Product Change Notification

Date Issued :	May 11, 2022	PCN Number :	511736
Reason for Change :	Change Supplier		
Description of Change :	This notification is to inform you about addition of new Supplier Celanese. That impacting the parts as per attached list. For product no impact to fit, form or function.		
Reason for Short Notice :	Special Request		
Assessment of Change :	First Article Inspection Reliability Test Report/s		
Planned Implementation Date :	August 10, 2022		
Sample Availability Date:	April 30, 2022		
Internal Molex Qualification Date :	May 23, 2022		
Last date to request Samples by Customer :	June 03, 2022		
Traceability Code Markings / Date :	Date code

Product Picture

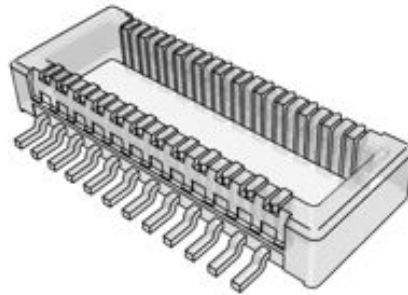
- Due to existing resin supplier Polyplastics capacity constraint issue, we must qualify second resin source to meet ramp-up demand. Current supplier Polyplastics don't supply any volume due to their limited capacity. We must qualify LCP supplier Celanese to avoid production line-down.

- Product Impact
 - no impact to fit, form or function

- We only change LCP resin supplier but the resin LCP 30% GF BLACK UL94V-0 is not changed
 - ✓ Before: Polyplastics LCP E130i-BK205P
 - ✓ After: Celanese LCP E130i-BK211P
